RE: Response to Comments, Traffic Review of a Full Access Driveway on Rapp Road from US 20 to Crossgates Mall Ring Road, Town of Guilderland, Albany County, NY
JMT Job No. 20-02057-001

JMT of New York, Inc. (JMT) prepared this response to the comments provided in a letter from GPI dated June 15, 2022. Enclosed with this letter is the preferred concept plan for Build Year 2022 Alt 2 of Rapp Road between US 20 and Crossgates Mall Ring Road for review. JMT's responses to GPI's review comments are as follows:

ALL DIMENSIONS IN FT UNLESS OTHERWISE NOTED	CONTRACT NUMBER
CONCEPT PLAN	DRAWING NO. RWY-1 SHEET NO. 1

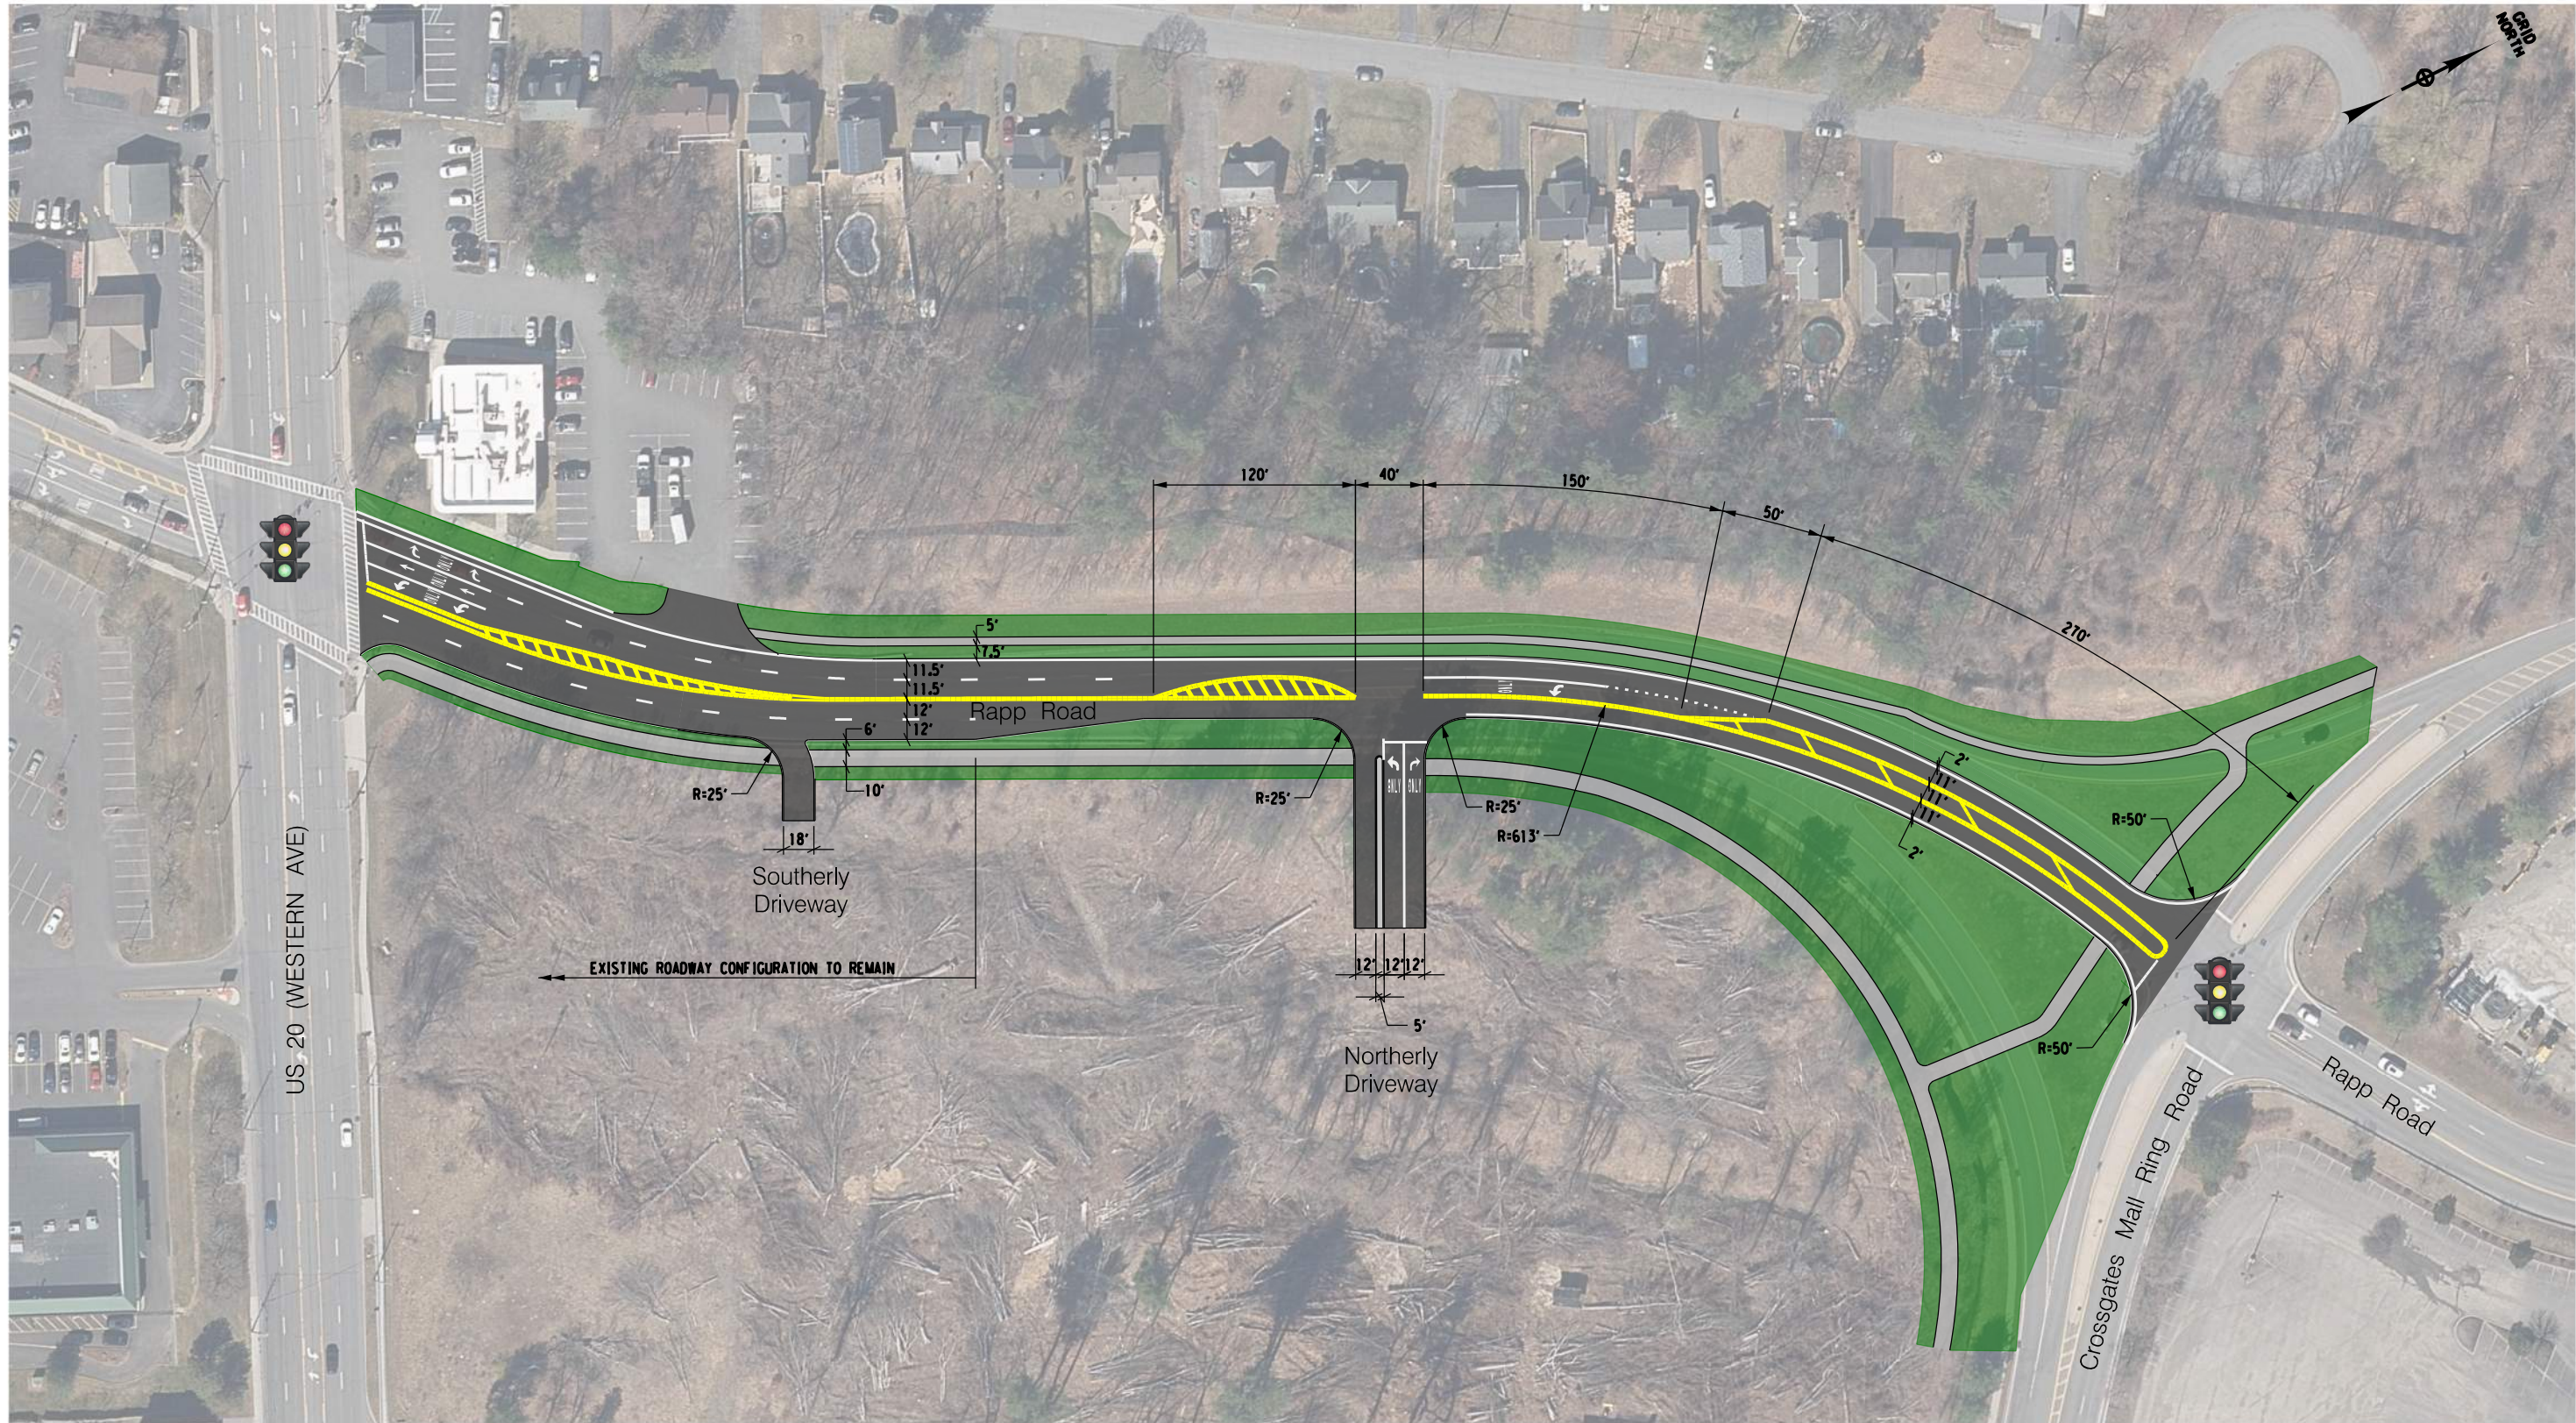
4. Comment: With sight distance to the north being less than desirable and the potential for southbound queues to block the site driveway, a review of the driveway access concept needs to be completed before final determination on the site access configuration can be determined. Items to consider in this concept include:
 - a. The original concept of having a separated receiver lane for driveway traffic that merges with Rapp Rd through traffic farther south is unacceptable. The queuing from the US Route 20 signal will

- extend too far back to allow for proper weaving and maneuvering to get into the correct lane at the signal.
- b. The proposed concept must include some type of refuge area for left turn vehicles exiting the site, so they can perform a 2-stage left turn maneuver and not cross directly into the Rapp Rd through traffic travel lanes.
 - c. The access concept needs to maximize available southbound queuing accommodations at the US Route 20 signal to reduce to likelihood of queue back-ups to the full access driveway.

5. Comment: It is clear that the reduced sight distance to the north and the queue back-ups southbound result in the full access concept having more impacts on Rapp Rd traffic operations and safety than Alternative 1 (right-in/right-out). Perhaps with the proper driveway access design, this can be mitigated to the point where the full access benefit outweighs the impact, but that is yet to be seen. We can make a better determination concerning this once a new access concept is presented.

Response: The attached "Concept Plan" details the proposed full access driveway and road diet of Rapp Road between US 20 and Crossgates Mall Ring Road. This concept plan is the preferred alternative for the Build Year 2022 Alt 2 scenario. (a) The corridor is striped throughout and no raised barriers are provided. (b) A transition area is provided on the south side of the Rapp Road/Northerly Driveway intersection for exiting vehicles to wait before entering the southbound traffic. This configuration discourages southbound thru traffic from crossing into the inner travel lane until 120 feet south of the intersection. (c) As indicated in the attached "Concept Plan: Queue Lengths" graphic, the queues from US 20 southbound will not back up to the Rapp Road/Northerly Driveway intersection.

Response: JMT reviewed multiple concepts to create a road diet on Rapp Road using pavement markings. This alternative provides adequate protection for vehicles entering and exiting Rapp Road while maintain acceptable operations on Rapp Road.

CONCEPT PLAN
QUEUE LENGTHS

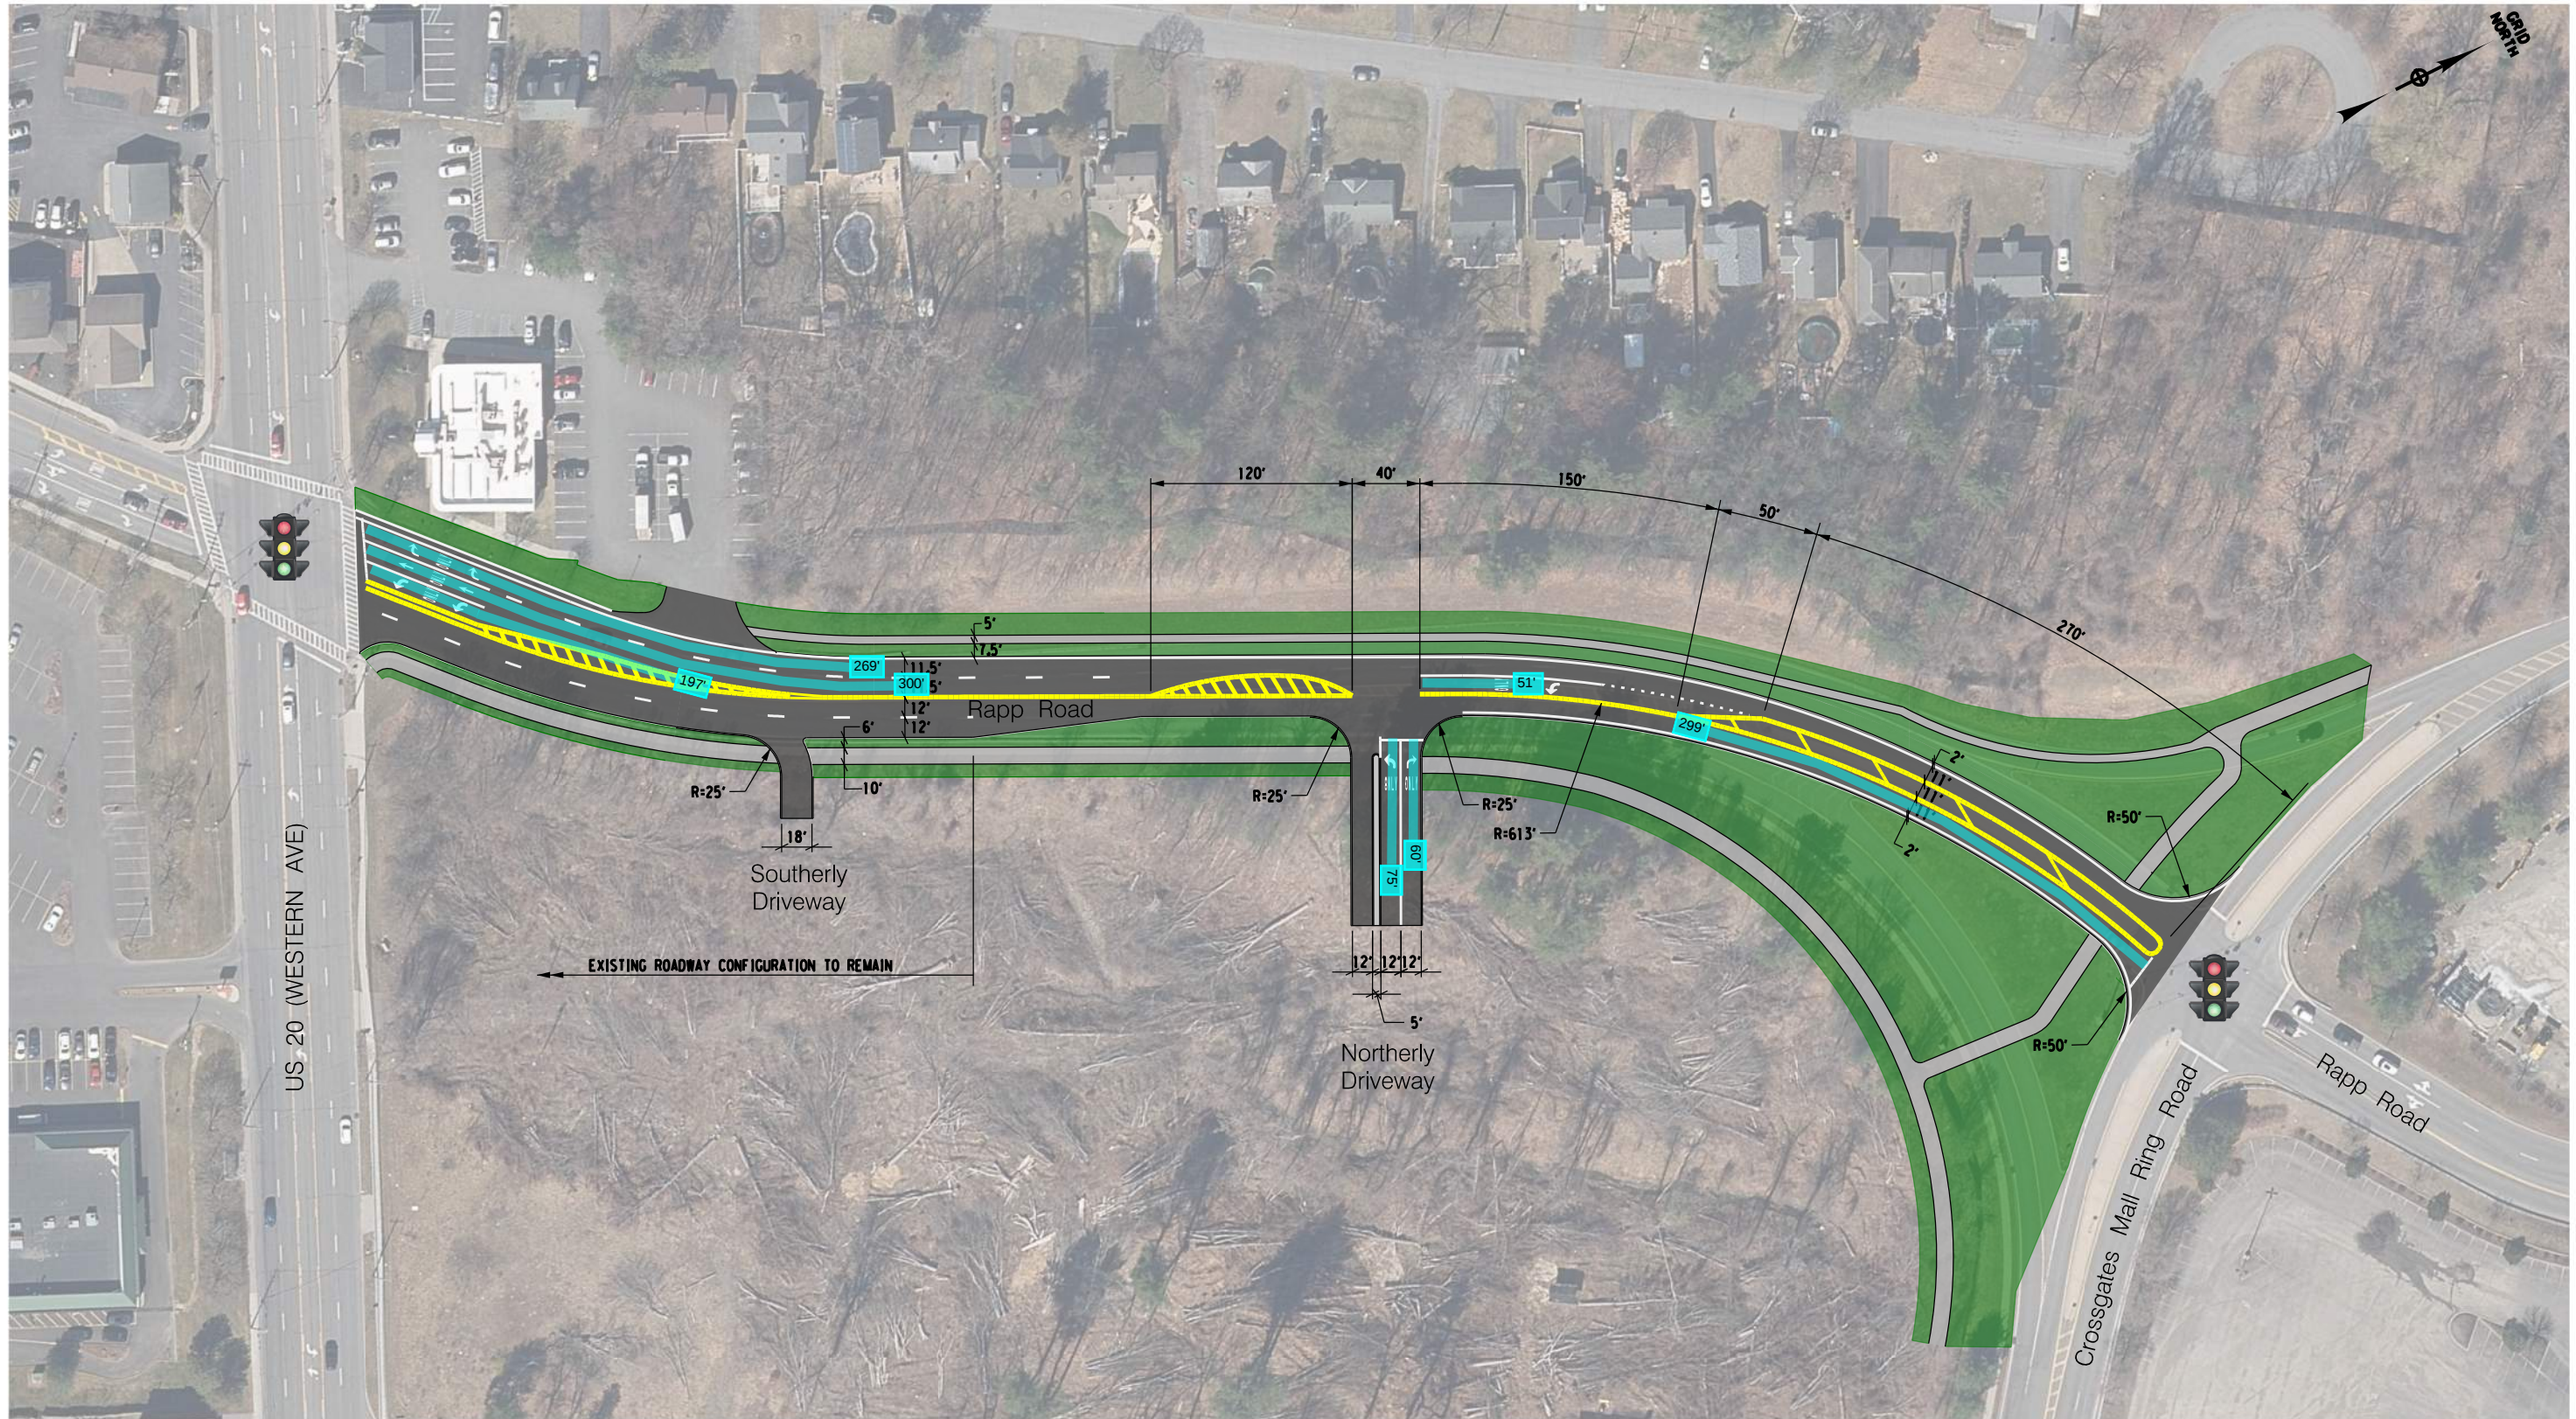
3. Comment: The simulation models show southbound queues along Rapp Rd from the US Route 20 signal backing up near, and occasionally past, the proposed Costco full-access driveway in the Build condition with road diet in place. These queues are slightly higher than Alternative 1 queues and a full access driveway could impact site driveway operations, where site vehicles may not be able to exit the site during times that the lengthy queues are present. These queues dissipate each signal cycle, so the blockage times should not be significant, but they will likely impact safety.

Response: The SimTraffic results for the 95th percentile queue during the Build Year 2022 Alt 2 weekday PM peak hour are shown in the attached graphic "Concept Plan: Queue Lengths". The queues from the SB approach to US 20 and NB approach to Crossgates Mall Ring Road do not back up to the full access driveway.
